From: [Craig Weinhold](#)
To: [Urban Design Comments](#)
Subject: Urban Design Committe agenda 6 / Woodland Preserve
Date: Sunday, December 14, 2025 12:39:56 AM
Attachments: [image.png](#)

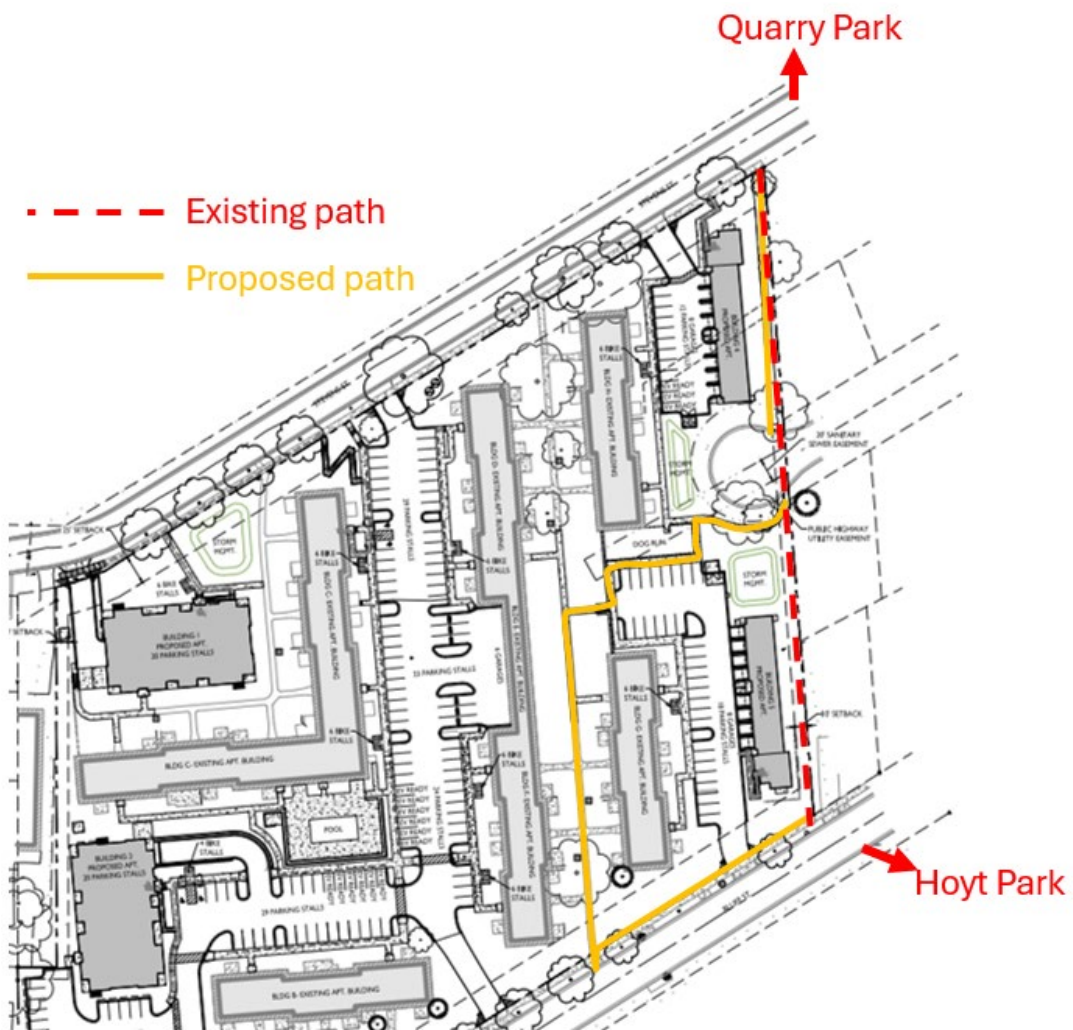
2. The developer's proposal for an east side path is not good (orange in the diagram below). The current path is heavily used by the public, even in its derelict state. It is the direct connection between Quarry Park and Hoyt Park. The City should hold firm that the path must remain approximately where it is today, that it be made ADA compliant, and that Woodland Preserve maintain it in a usable state. The utility pole with the problematic guy wire can be reengineered or the utilities can be buried. This path has been in public use for 50+ years, far longer than the twenty years required for adverse possession. If Woodland Preserve won't agree to maintain the path where it is, the City should take steps to claim ownership of the land.
